**SB-10052413-6764**

**Title: TerraStar Torsion Bar Retention Cotter Pin Design Change****Applies To: TerraStar built before 1/31/2013****DESCRIPTION**

**Figure 5**

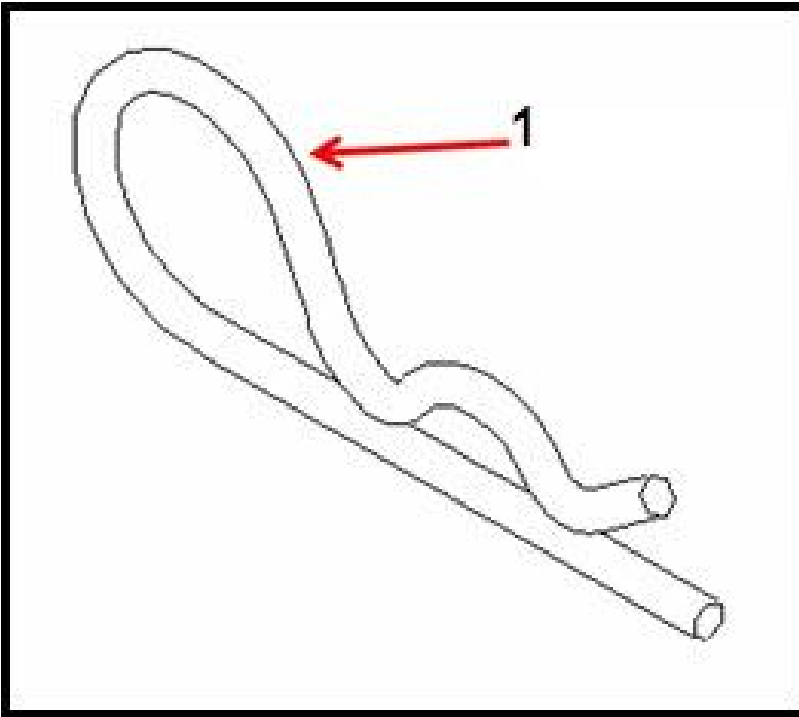
5. Differences between old and new cotter pin (*Figure 5*).

A replacement cotter pin with a smaller loop has been put into production as of 1/31/2013. Should it be desired, the cotter pin on the trucks built prior to this date may be swapped with P/N 6102322C1 (the old part number was 3531907C2).

1. Loop reduced from 5/8" to 3/8"
